From: Griffin, Tim (Contractor)
Sent: 13 March 2025 17:56
To: Harrison, Liz
Cc: Oliveira, Marta (Contractor); Dyer, Tim; Ellison, Mark
Subject: Re: F/24/97945 LAND ADJACENT TO OAK COTTAGE, WINCHESTER ROAD, BOORLEY GREEN - 52 retirement living apartments - landscape comments

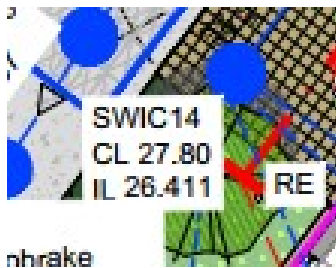
c/ This Oak tree is too close to the building. Relocate. We welcome Oaks

Although the accompanying consultee response note states this tree has been moved (which it has), it is still less than 5m from the new build. This is far too close to the building for such a canopy species. This tree should be swapped with one of the Birch to the E of parking bays 9 & 10 where there is more room for growth.
